# West Oakland Link Initial Study/ Mitigated Negative Declaration Addendum

**NOVEMBER 2024**

### 1.3 Proposed Revised Project

Figure 1-4a

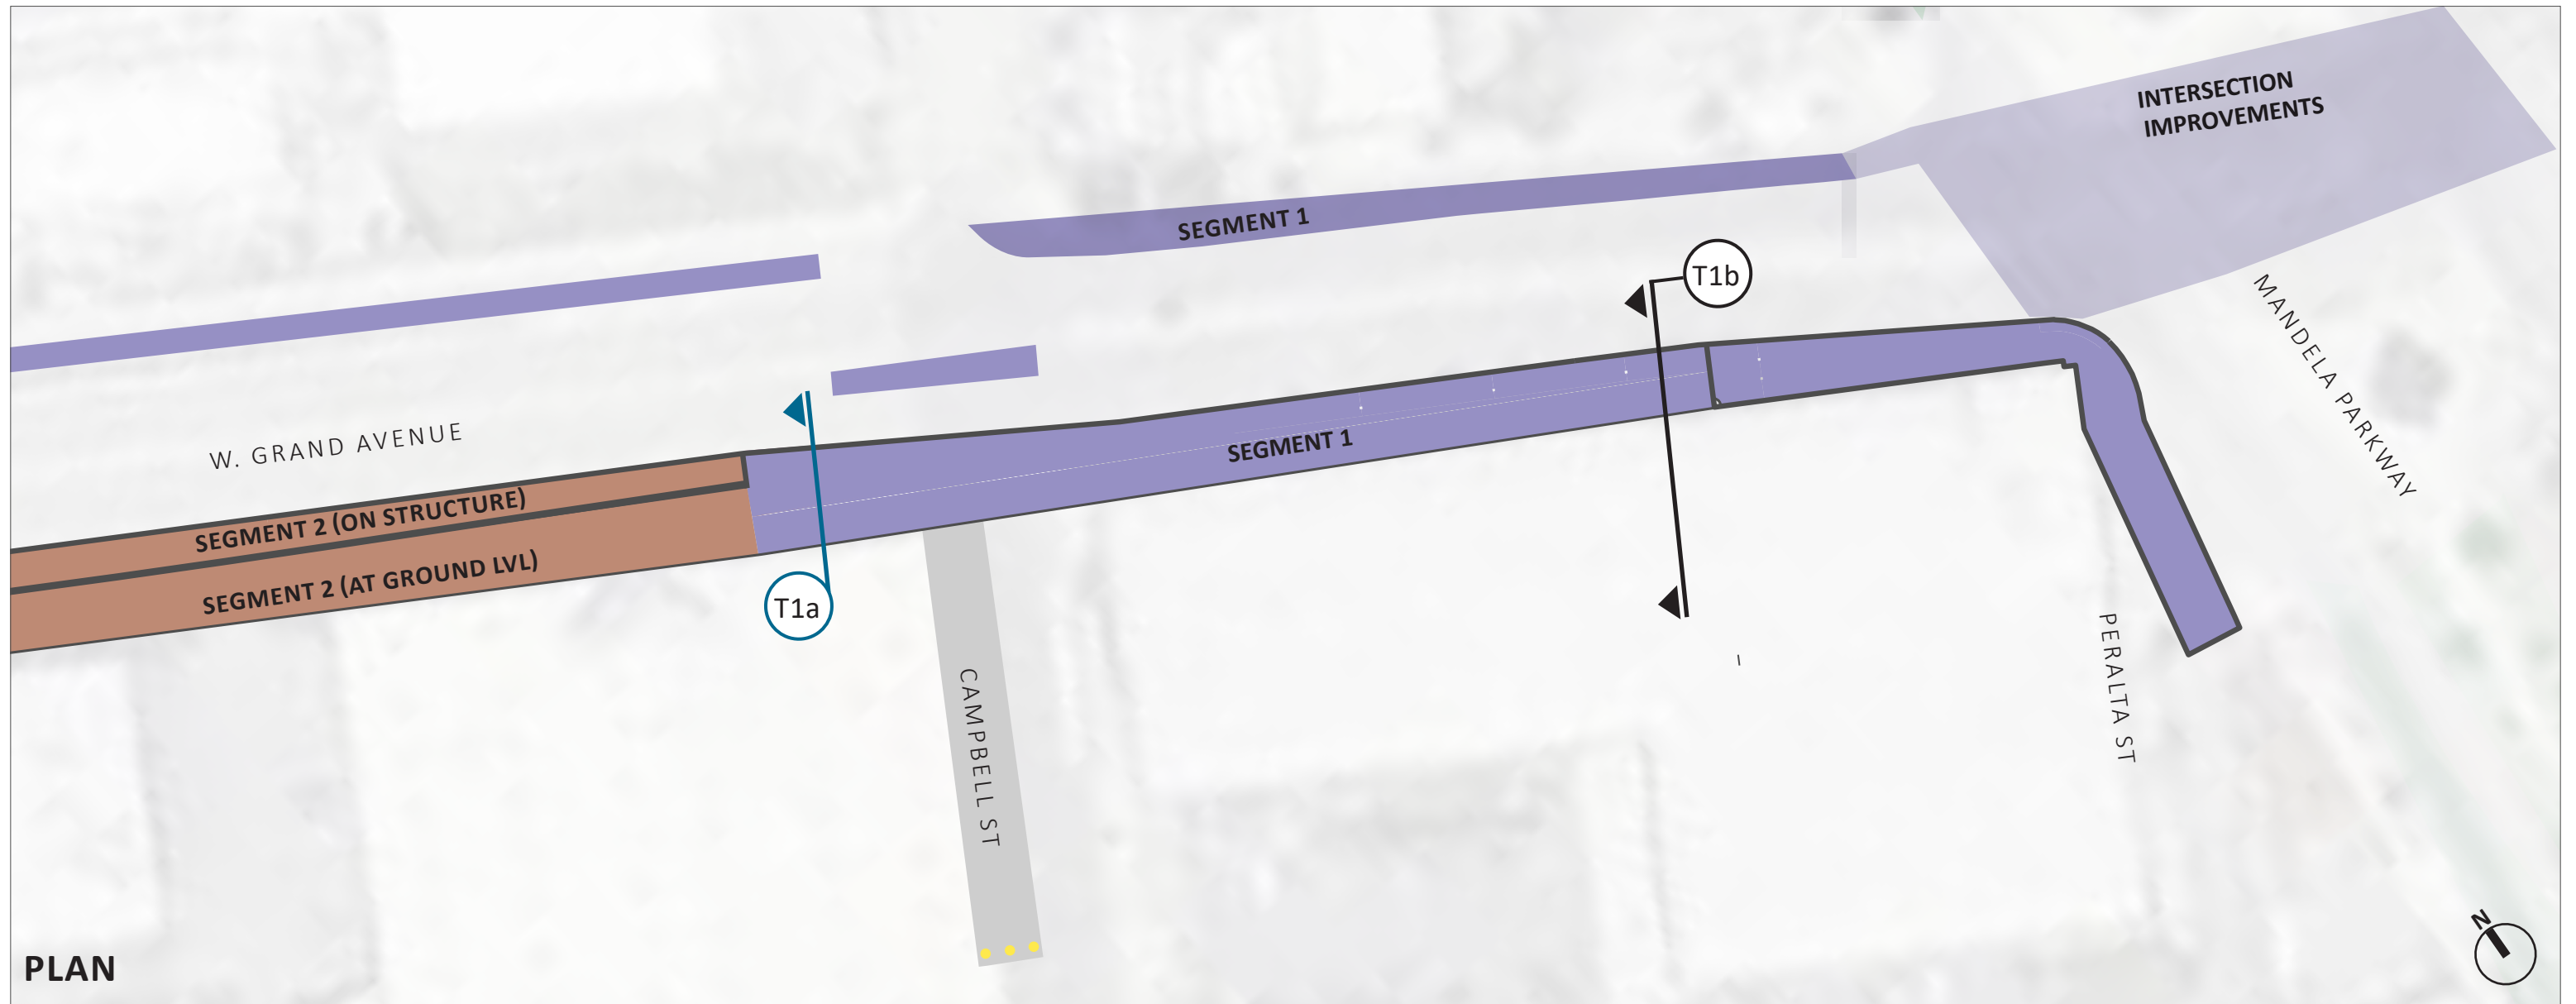
The Proposed Revised Project would add safety treatments on Peralta Street (e.g., a raised crosswalk where Peralta Street intersects Mandela Parkway, curb extensions on the north and south sides of the intersection, pedestrian ramps, a raised island, additional bike markings). The Proposed Revised Project would also include improvements at the intersection of Mandela Parkway and West Grand Avenue.

Figure 1-5b

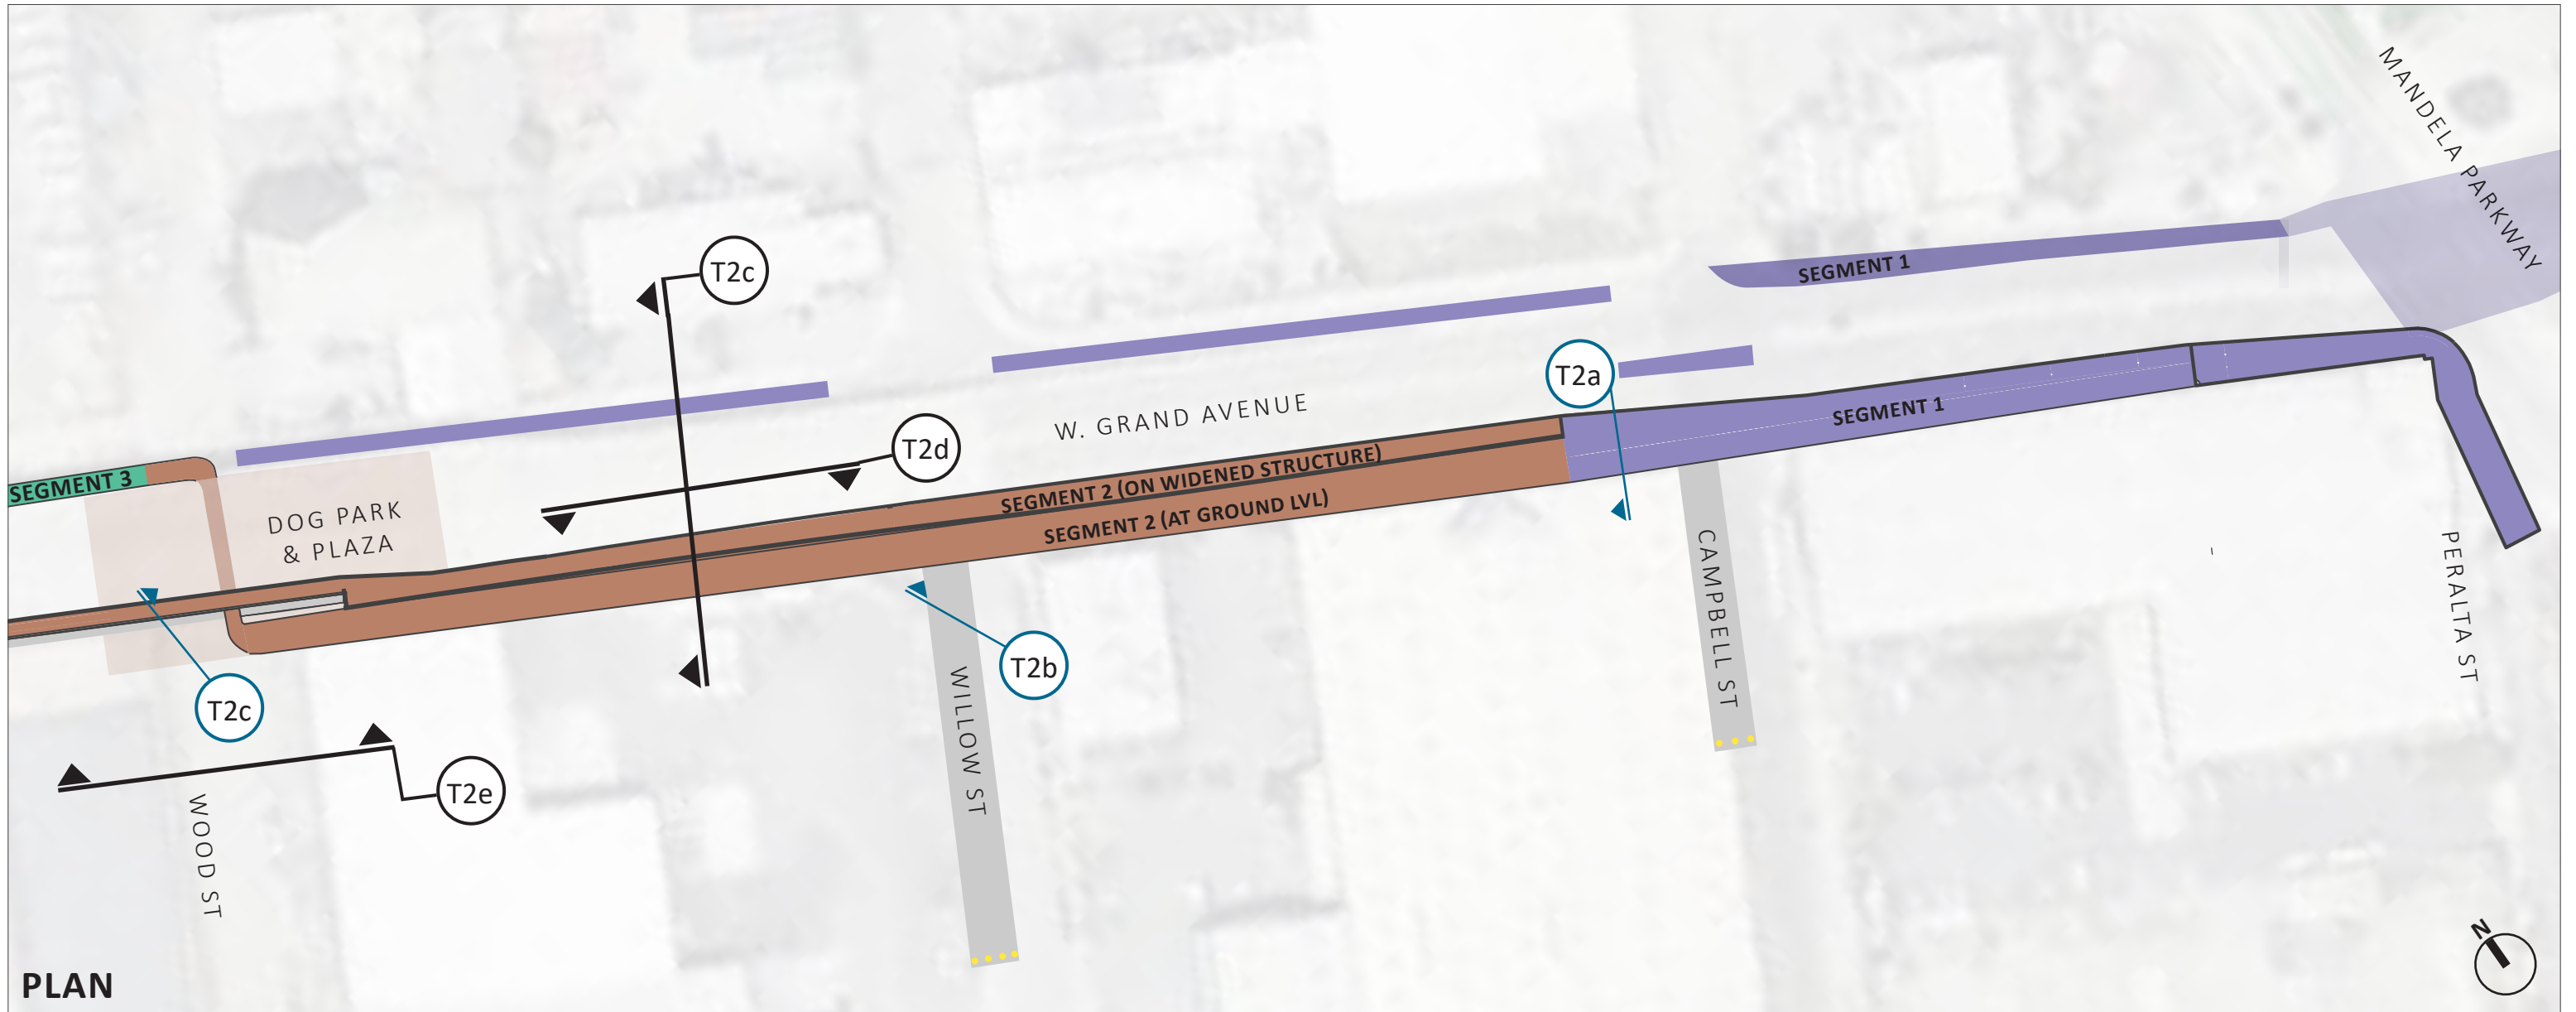
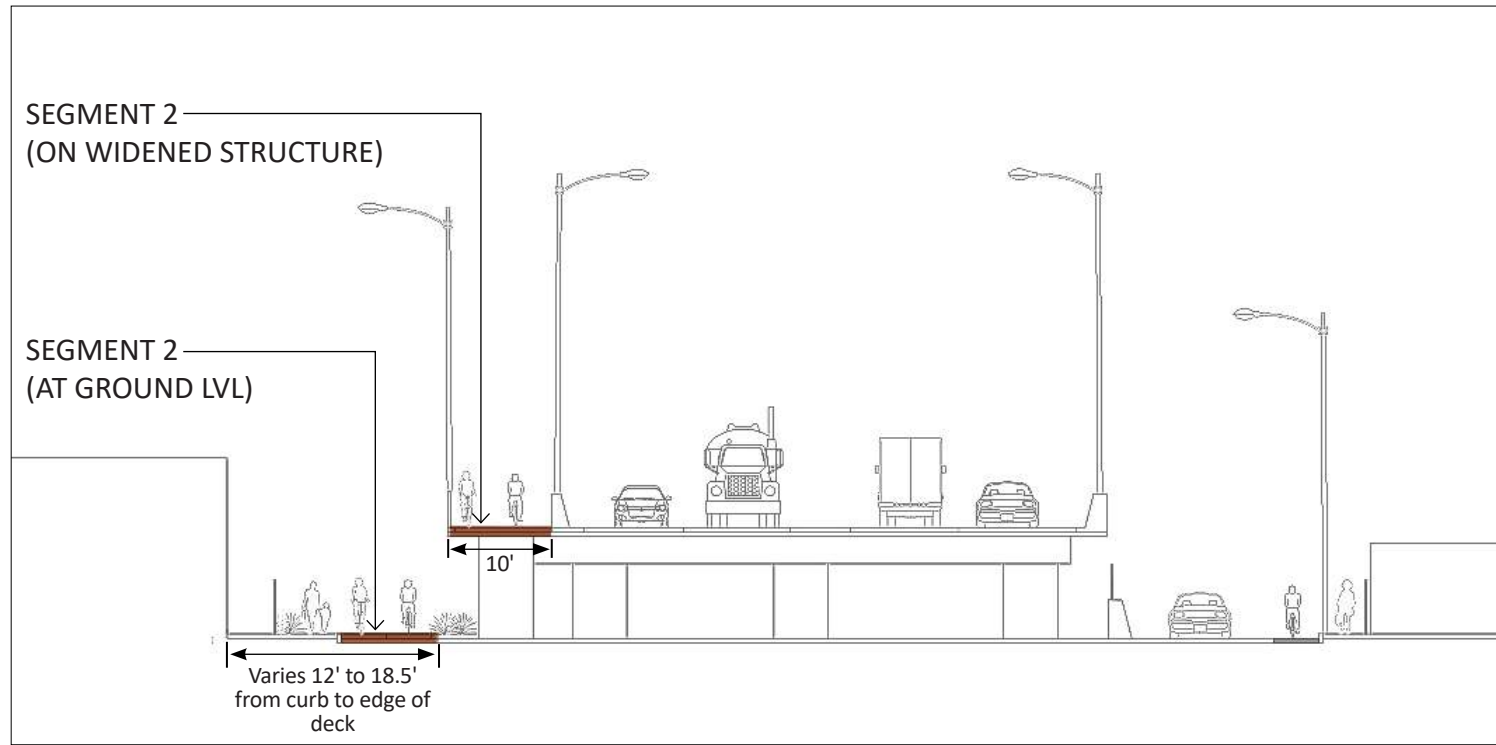
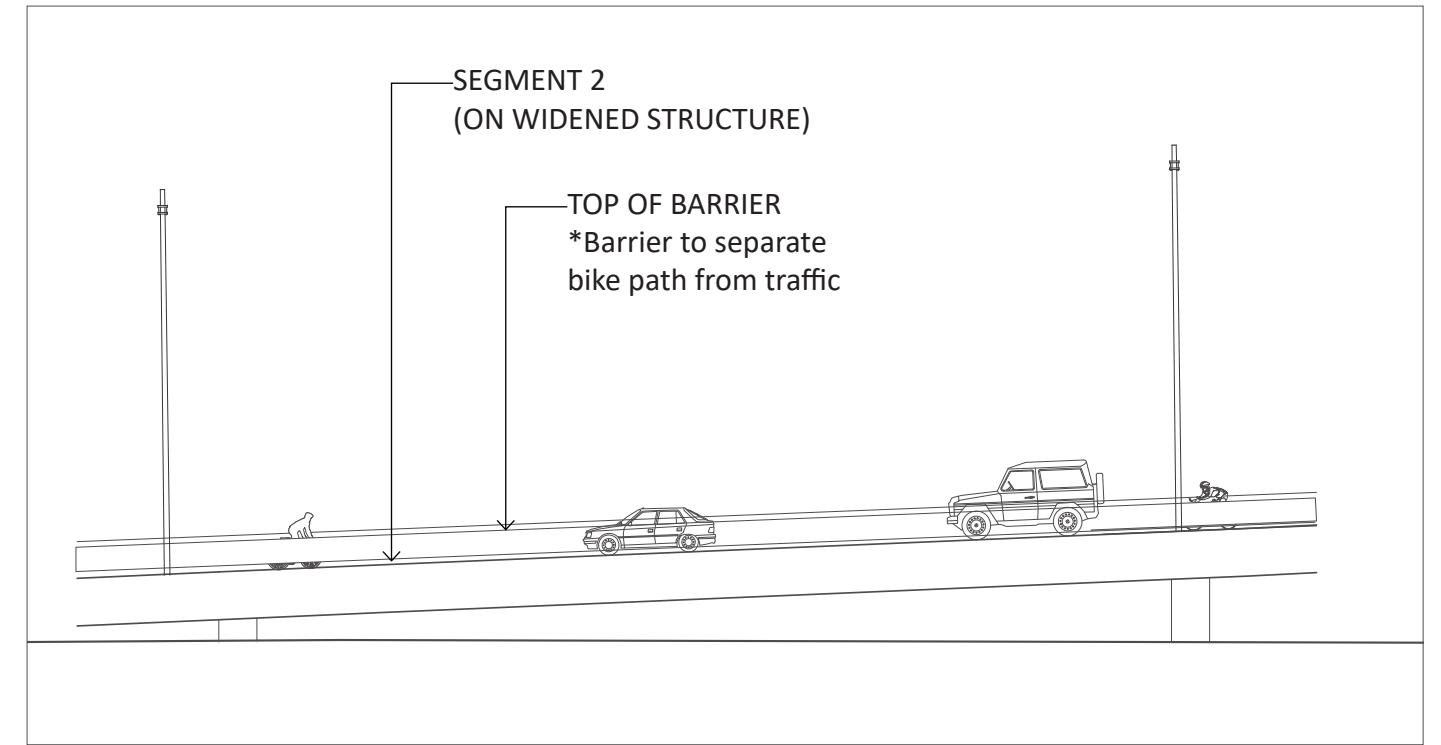
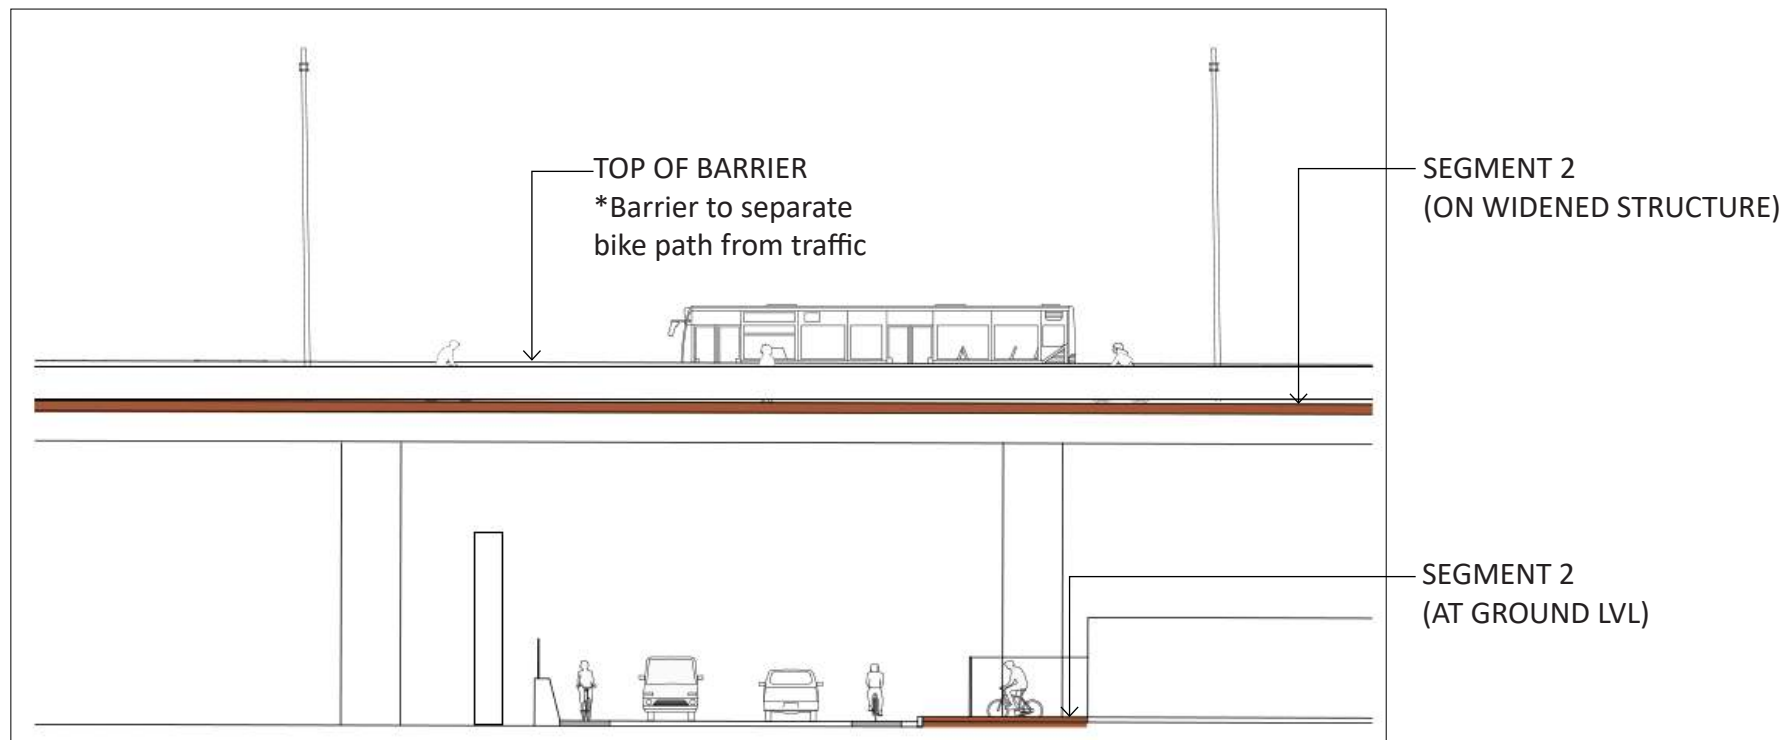
As shown in Figures 1-5a and 1-5b, the Proposed Revised Project would have two separate parallel paths. Path 1 would be as generally described for Segment 2 in the Adopted IS/MND. However, it would be reduced from 15 to 10 feet in width and require the widening of the West Grand Avenue structure between Willow Street and Campbell Street. It would then transition to the existing West Grand Avenue structure just east of Wood Street. The path would continue for about 310 feet on the existing West Grand Avenue structure to Frontage Road, between Frontage Road and the area east of Wood Street. The space created by reducing the number of vehicular lanes in the westbound direction would be used to accommodate the 10 feet path and a safety barrier. Path 2 would be a separate path that would allow users access from the planned Wood Street bicycle corridor; it would also allow them to avoid the Frontage Road crossing. It would include approximately 860 feet of at-grade pathway, using the south West Grand Avenue alley between Campbell Street and Wood Street, and then continue approximately 100 feet on the east side of Wood Street underneath the West Grand Avenue structure.
